THE MEMPHIS DEPOT TENNESSEE

TECHNICAL MEMORANDUM

Final Field Sampling Plan Addendum for Operable Unit (OU) 4

DATE: September 25, 1998

Figure 1
RJ Site 57, Building 629
Constituents Exceeding Risk-Based Criteria
Defense Distribution Depot Memphis, TN

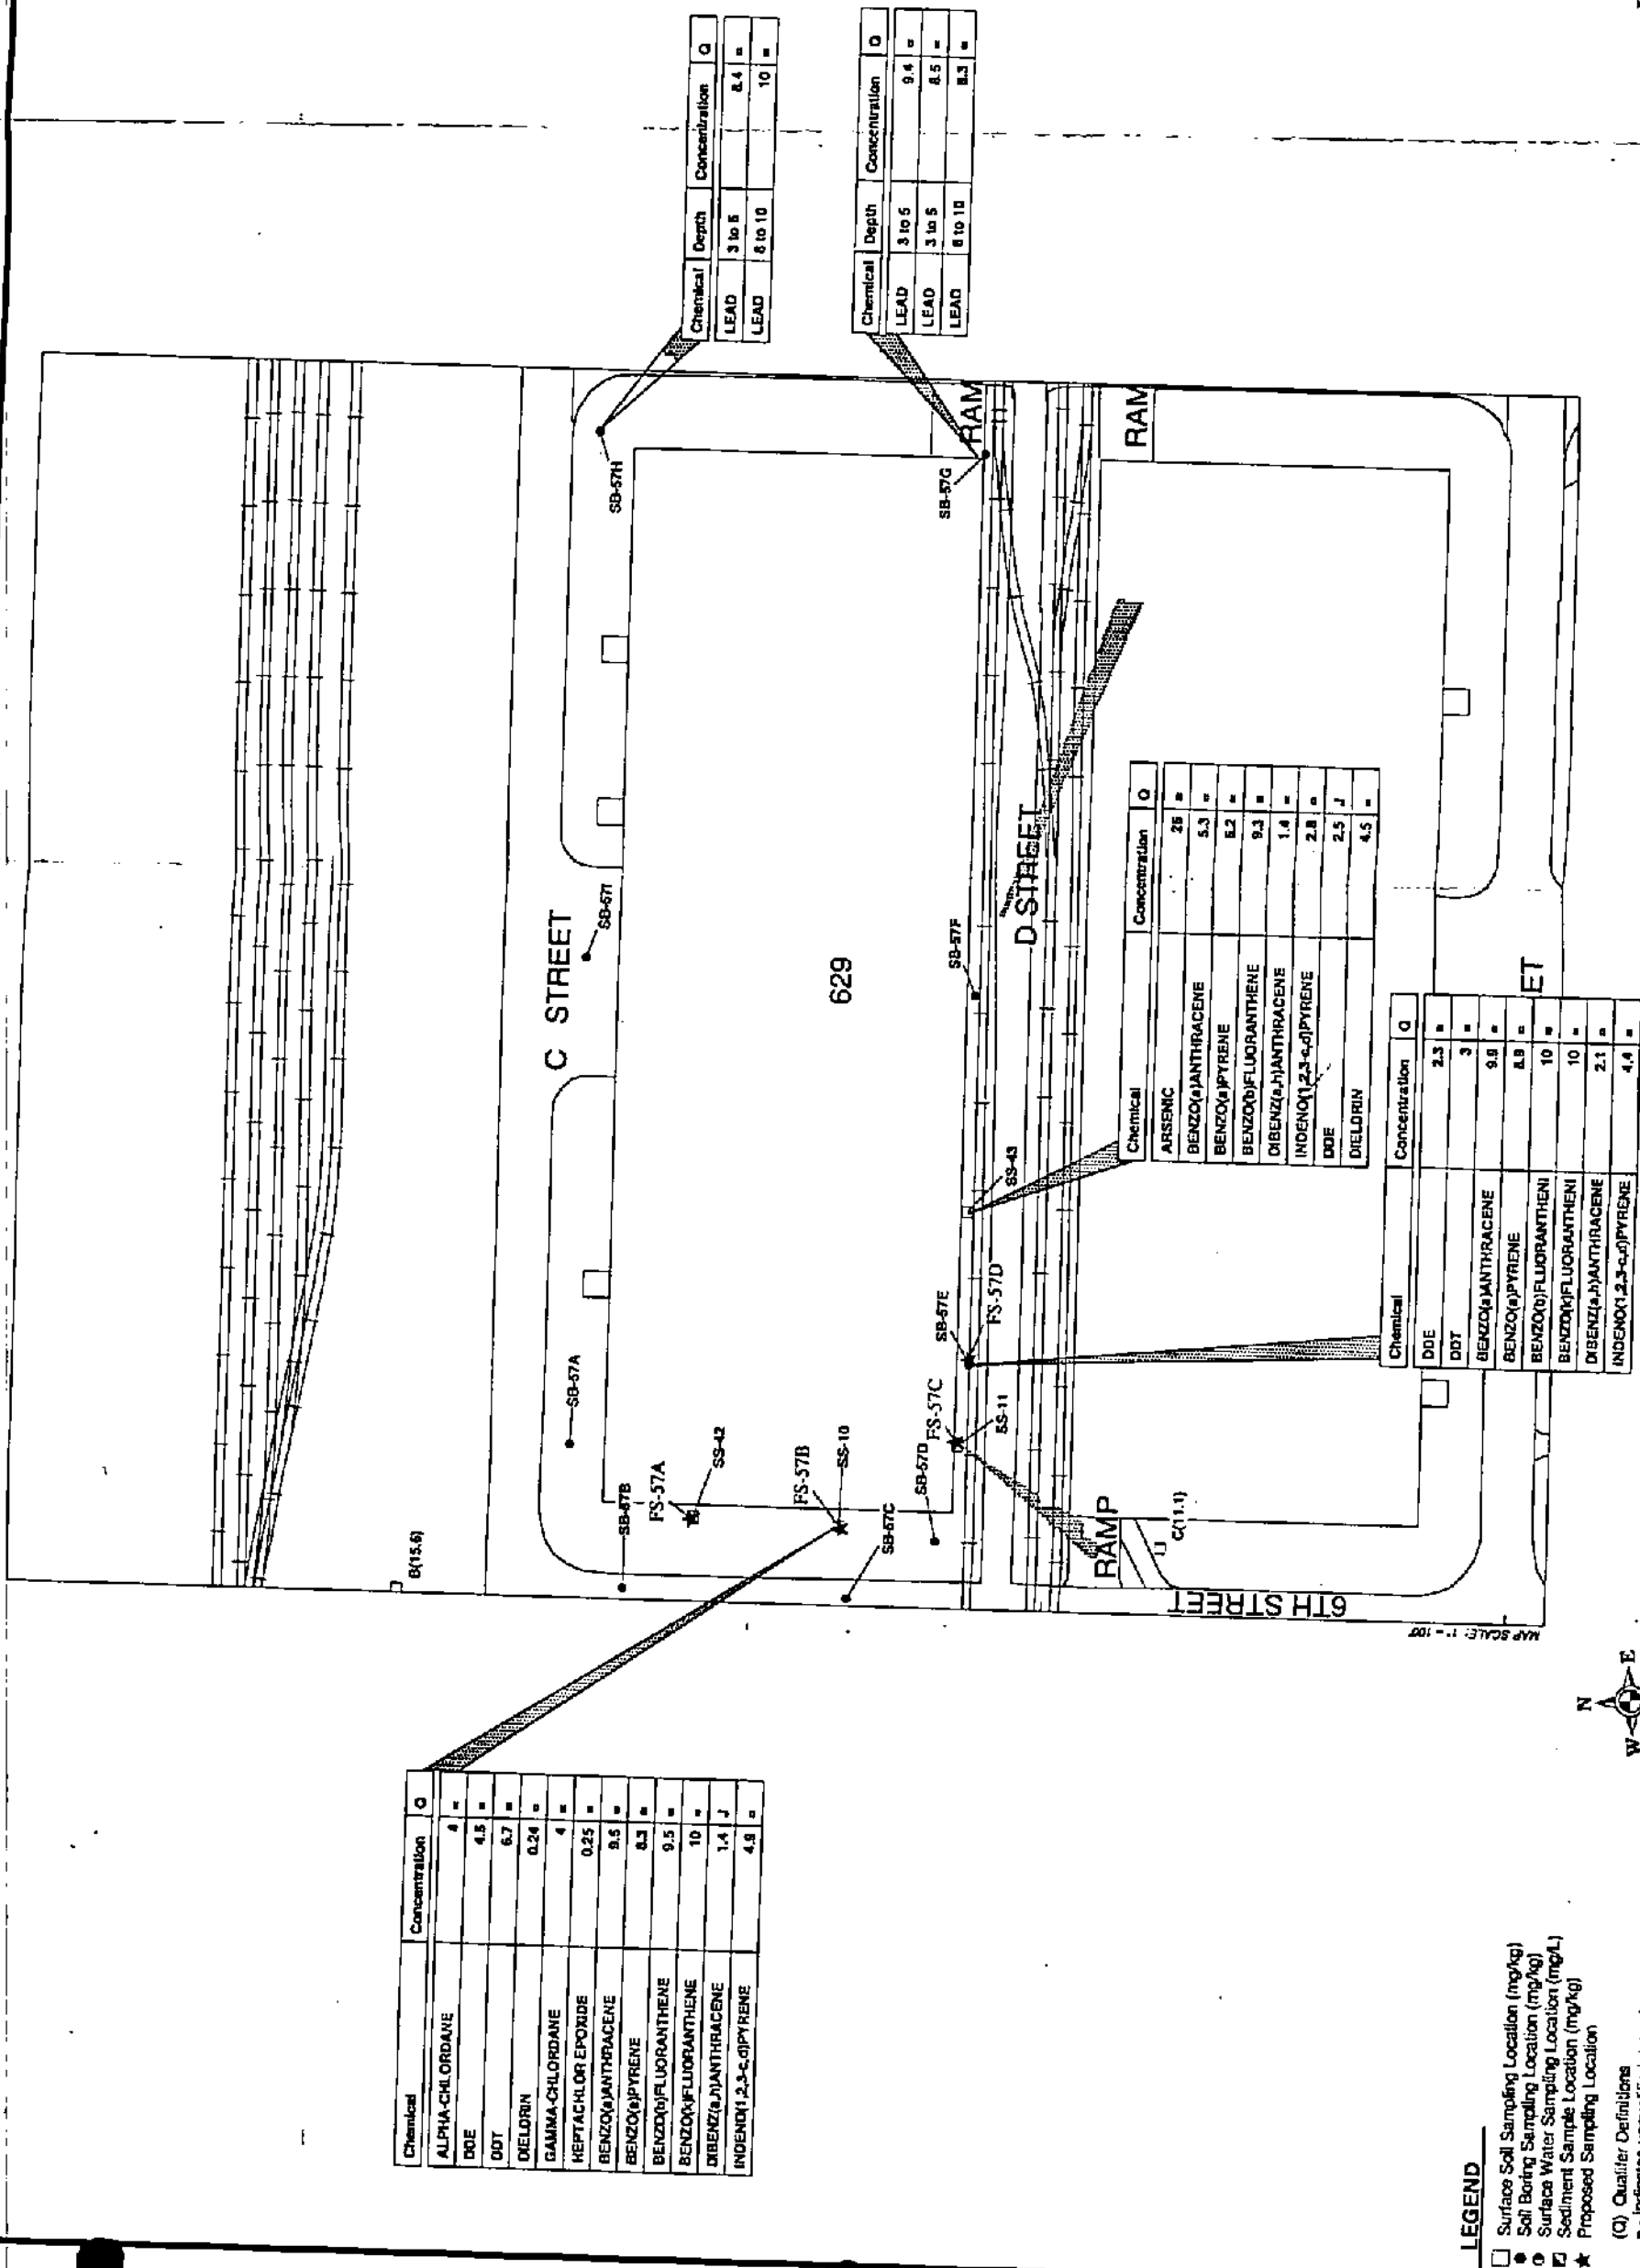
Additional samples are needed at this site for Feasibility Study information to determine the depth of soil removal. A total of 12 surface soil samples (FS57A through FS57D) will be taken along the foundation of Building 929 west and southwest of the building. The samples will be collected from four locations at interval depths of 0 to 6 inches, 0 to 12 inches and 0 to 18 inches. One sample location south of Building 929 and one sample location west of Building 929 will be analyzed for PPM (Priority Pollutant Metals) and PAH compounds. The other two sample locations south and west of Building 929 will be analyzed for PAH compounds only. Specific sampling information is presented in Table 1.

See Figure 1 for location of proposed additional samples and a summary of previous data collected at Site 57.

In response to EPA Region IV comments regarding asphalt and RR tracks as a source of PAH contamination, one sample of road asphalt and one sample of creosote oozing from the railroad tracks will be obtained at Site 57. These samples will be taken south of Building 629, just south of the sample site SS-43. Both samples will be analyzed for PAHs and PAH TCLP.
